Alaska Power Authority
334 W. 5th Ave.
Anchorage, Alaska 99501

Comment 9a (p. E-7-69, Section 5.4.1)

Compare information common to Section 5.4.1 through Section 5.4.5, Section 6.1.6, Tables E.7.17 and E.7.18, and Figures E.7.7 through E.7.17 and correct all discrepancies with respect to (1) phasing of development, (2) proposed facilities to be provided, and (3) estimated costs of "recreation plan project features".

MAP 1

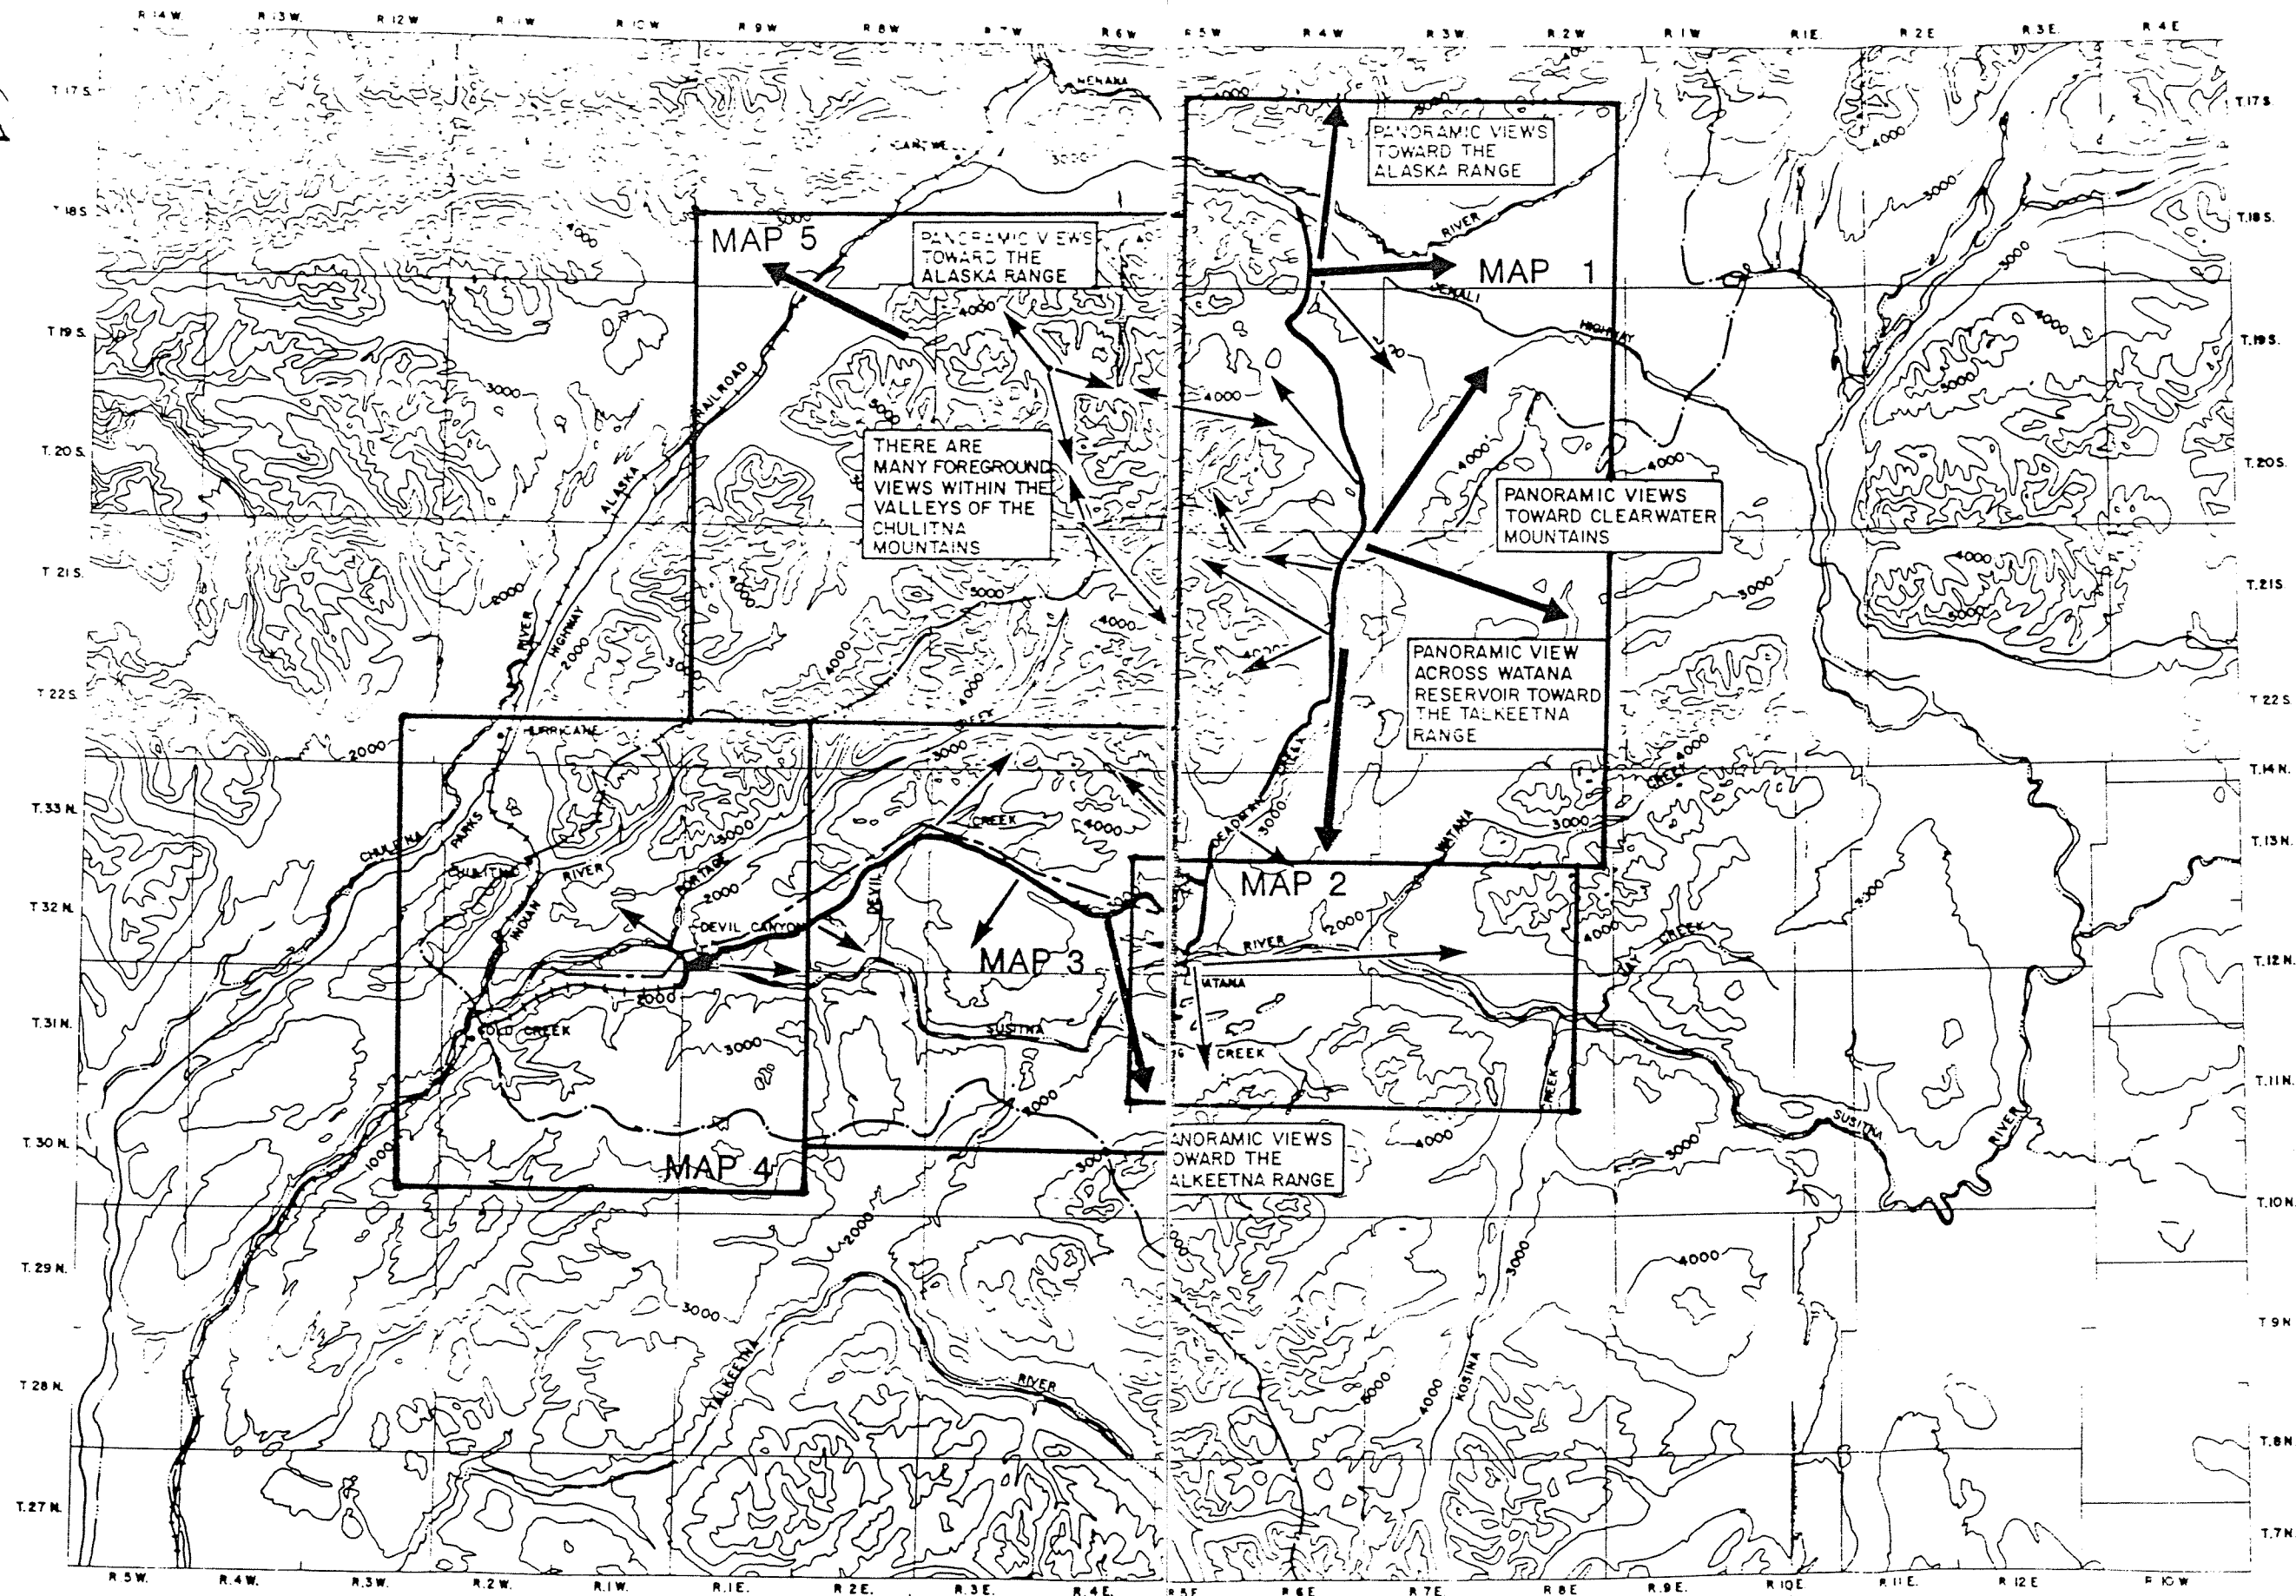
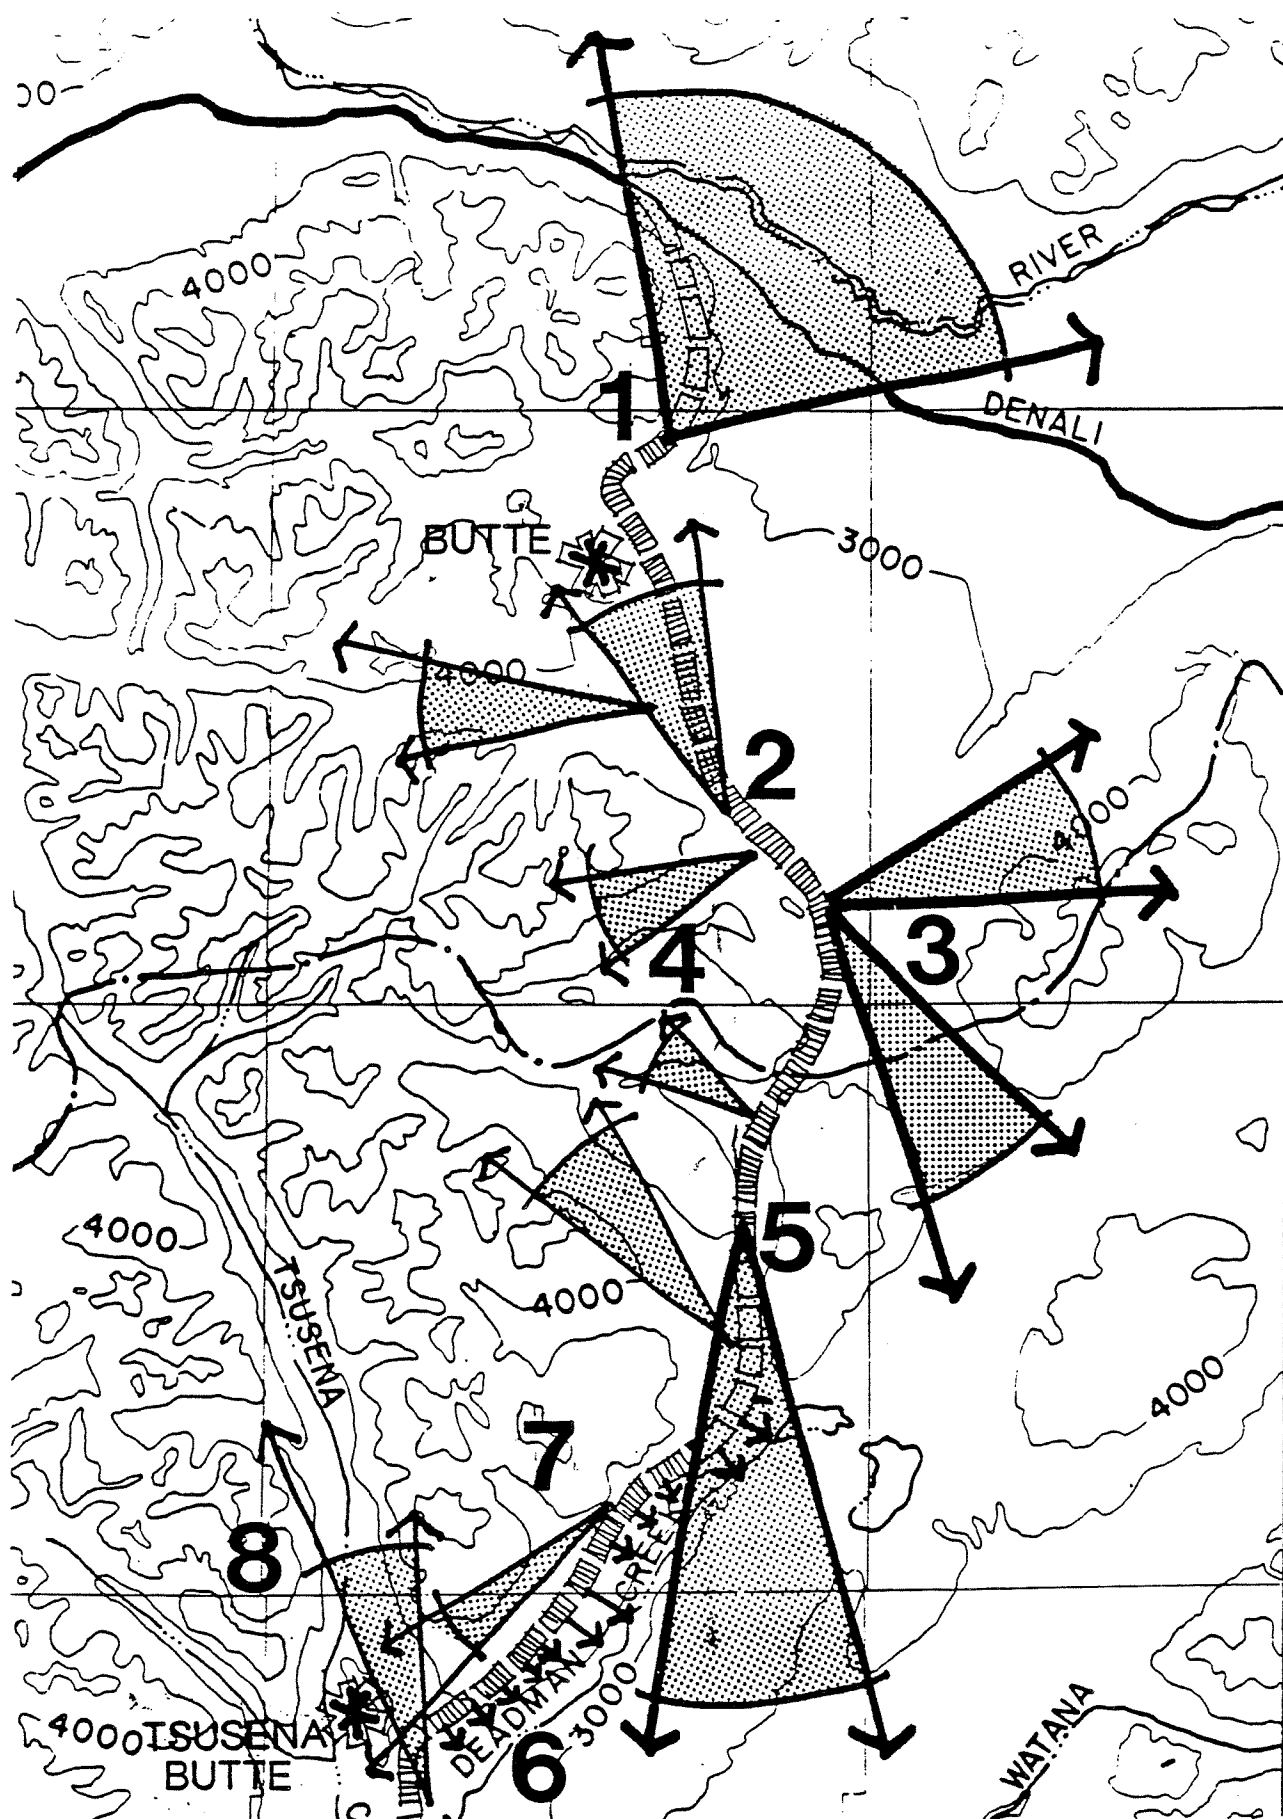
Provide a brief description (e.g., viewer vantage point, viewing distance, number of potential viewers, duration of view) of those significant views that are indicated on Figure E.8.8 and mentioned in the charts of Appendix 8.F. Provide a similar level of information for the transmission line corridor, including the intertie.

The following example identifies the types of view considerations that are delineated in Figure E.8.8 of Chapter 8, Exhibit E of the License Application. Additional information on views along the transmission line corridor is included in Part 2 of the response to Aesthetics Comment 7.

The remainder of this response provides view consideration information for the thirty views identified in Figure E-8-8 (see attached version of this figure). This information is keyed to the attached Maps 1-5.

LOCATION MAP: KEETNA SITE

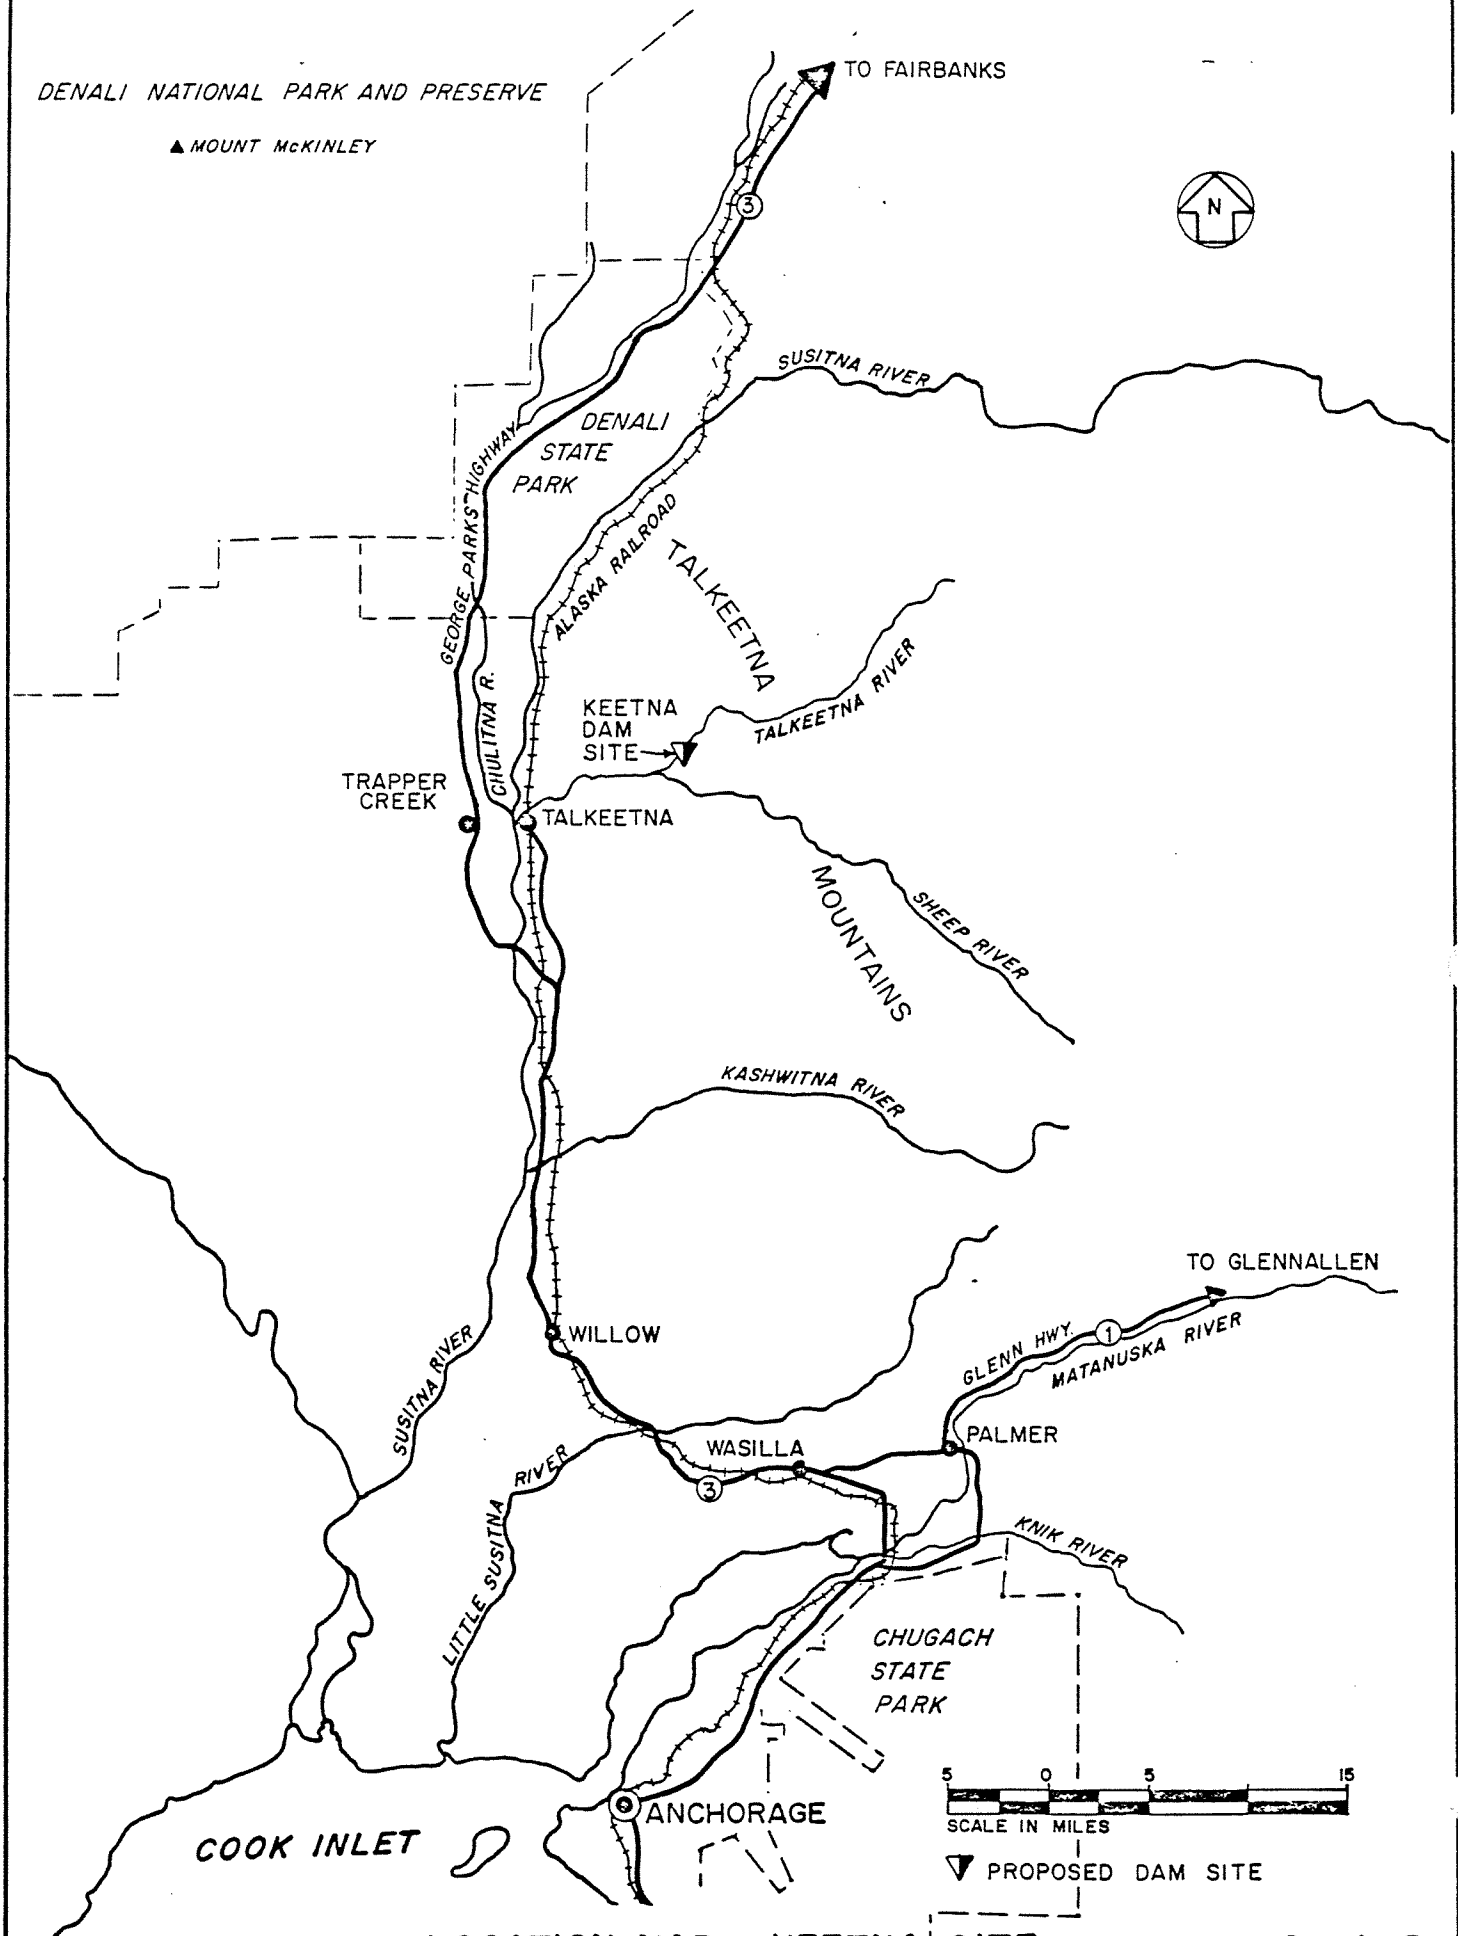
Provide a brief description of the identified land uses for the Keetna site.

Identified land uses in the area of the Keetna site (see attached map) are characterized by dispersed, low-intensity recreational and subsistence activities typical of remote areas in this region of Alaska. The closest land development consists of several homesteads at Larson Lake, approximately 13 miles southwest of the site (see p. E-9-20 in Chapter 9, Exhibit E of the License Application). Boating and off-road driving activities near the Keetna site are delineated in Figure E.7.4 in Chapter 7; fishing and boating are indicated activities further upstream. As described on p. E-7-22 in Chapter 7, approximately four to six boating parties are airlifted into Stephan Lake each year. In the site evaluation process (see Tables E.10.6 and E.10.7 in Chapter 10), the Keetna area was rated as having moderate recreational sensitivity (primarily due to existing and potential boating activity), and low agricultural, wilderness, and restricted land use sensitivities.
